SUBJECT: AMENDMENT NO. 106 TO FACILITY OPERATING LICENSE NO. DPR-50

THREE MILE ISLAND NUCLEAR STATION, UNIT NO. 1

AMENDMENT TO FACILITY OPERATING LICENSE

Amendment No. 106
License No. DPR-50

FIGURE 4.17-1
 SNUBBER FUNCTIONAL TEST - SAMPLE PLAN 2

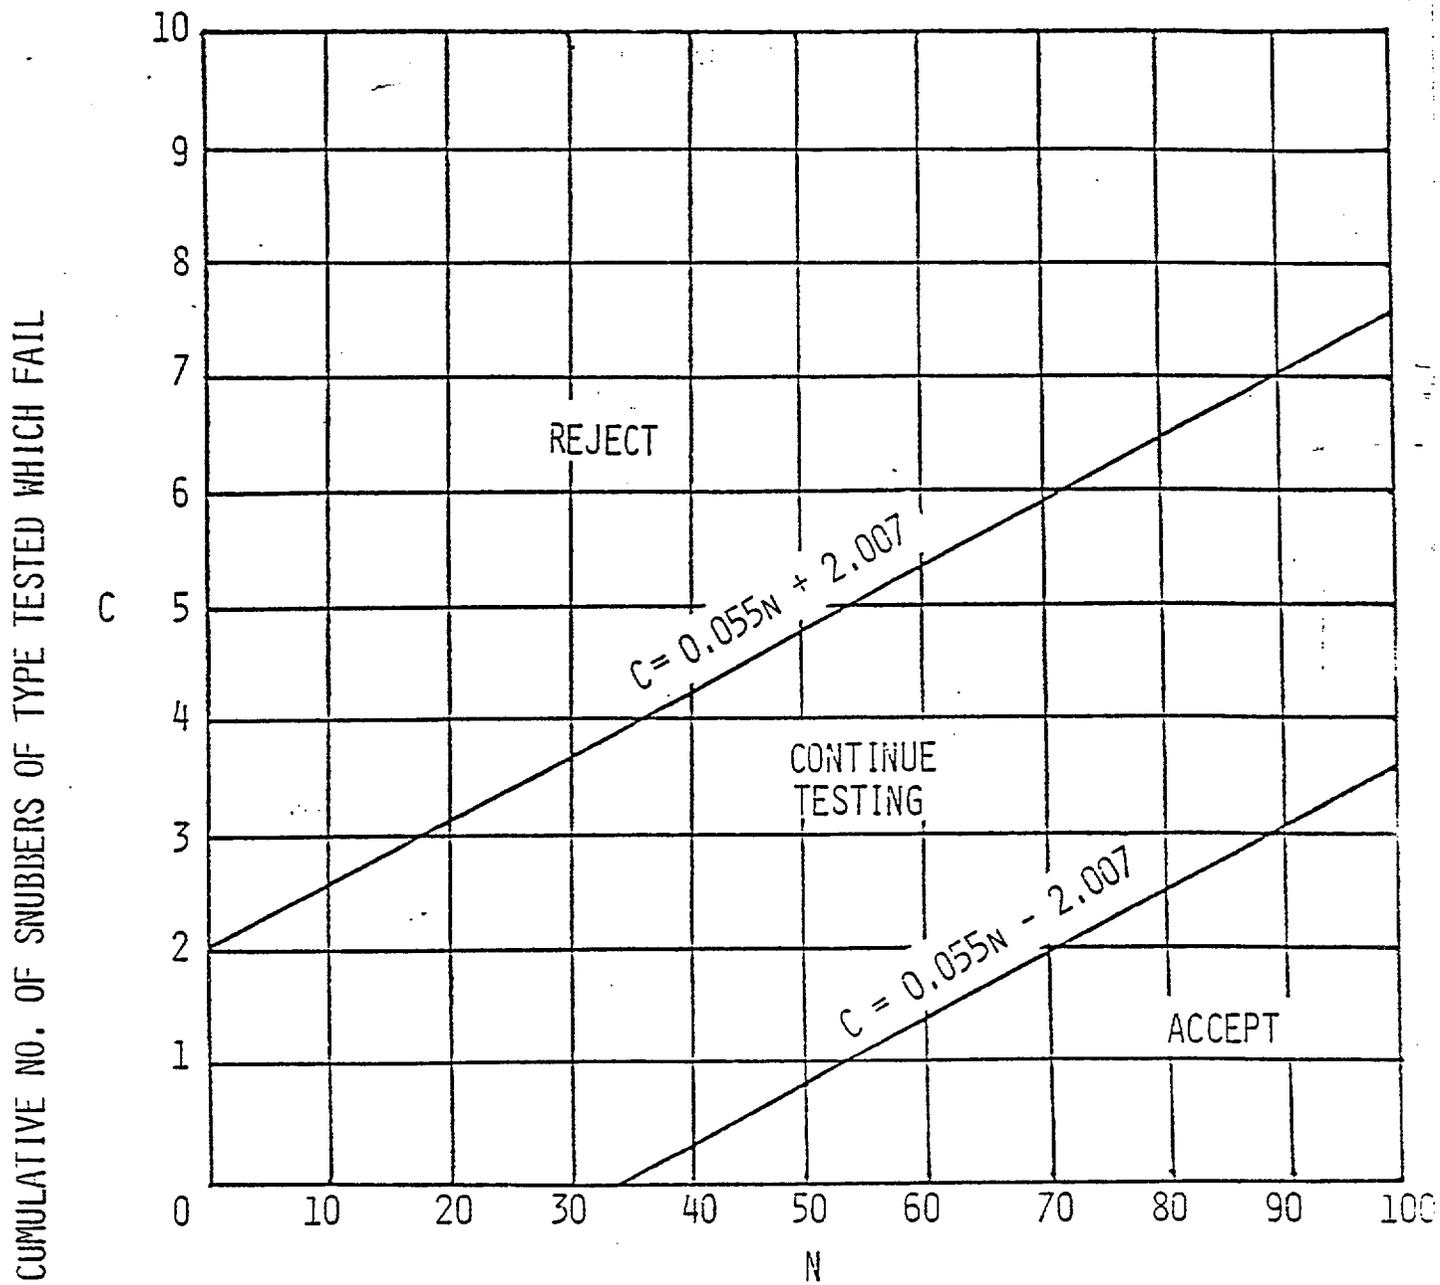
- 2) A representative sample of each type of snubber shall be functionally tested in accordance with Figure 4.17-1. "C" is the total number of snubbers of a type found not meeting the acceptance requirements of Specification 4.17.1f. The cumulative number of snubbers of a type tested is denoted by "N". At the end of each day's testing, the new values of "N" and "C" (previous day's total plus current day's increments) shall be plotted on Figure 4.17-1. If at any time the point plotted falls in the "Reject" region all snubbers of that type shall be functionally tested. If at any time the point plotted falls in the "Accept" region testing of that type of snubber may be terminated. When the point plotted lies in the "Continue Testing" region, additional snubbers of that type shall be tested until the point falls in the "Accept" region or the "Reject" region, or all the snubbers of that type have been tested. Testing equipment failure during functional testing may invalidate that day's testing and allow that day's testing to resume anew at a later time, provided all snubbers tested with the failed equipment during the day of equipment failure are retested.

1. Functionally test 10% of a type of snubber with an additional 10% tested for each functional testing failure, or
2. Functionally test a sample size and determine sample acceptance or rejection using Figure 4.17-1.

Figure 4.17-1 was developed using "Wald's Sequential Probability Ratio Plan" as described in "Quality Control and Industrial Statistics" by Acheson J. Duncan.
